To: T10 Technical Committee
From: Barry Olawsky, HP (barry.olawsky@hp.com)
Date: 10 July 2007
Subject: T10/07-304r1 SAS-2 Zero-Length Test Load Section

Replace the zero-length test load section with the following text and graphics.

1.1.1.1 Zero-length test load

Figure 105 — Zero-length test load for transmitter device compliance point

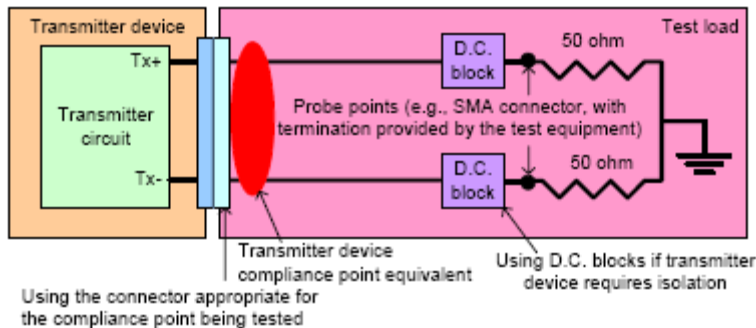
Figure 105 shows the zero-length test load as used for testing a transmitter device compliance point.

Test loads in a figures 105 and 106 show ideal designs. Physically implementable designs include insertion loss between the compliance and probe points and return loss due one or more impedance mismatches between the compliance point and 50 ohm terminations points. Also not shown are non-ideal effects of the test equipment such as additional insertion and return loss. Refer to Annex B for de-embedding methods to remove such effects.

Figure 106 — Zero-length test load for receiver device compliance point

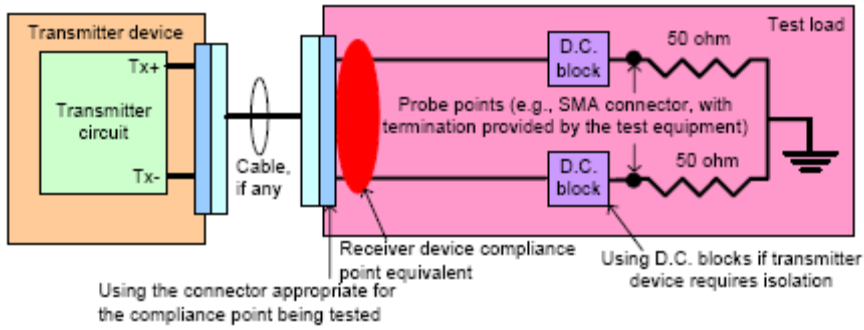
Figure 106 shows the zero-length test load as used for testing a receiver device compliance point.

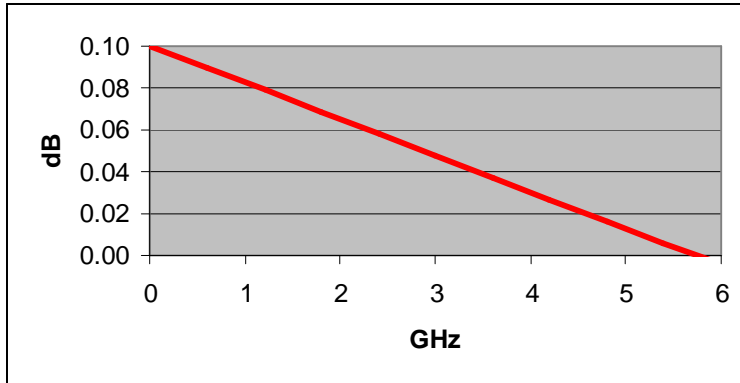
Adding a DC loss of 0.1dB and rescaling the “f” term to “3” to force 4.0dB loss at 6GHz the additional margin is:

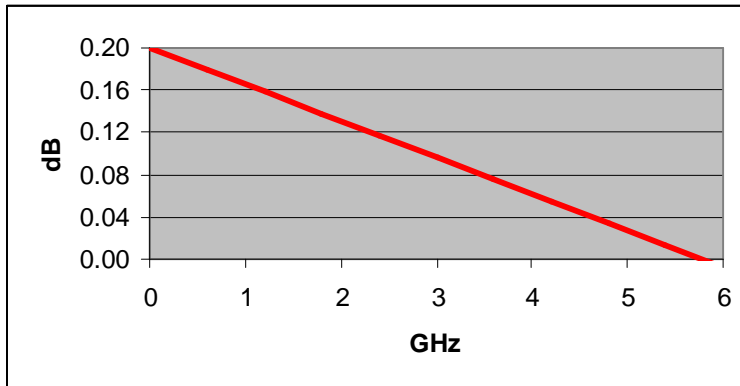
Adding a DC loss of 0.1dB and rescaling the “f” term to “2.8” to force 4.0dB loss at 6GHz the additional margin is:
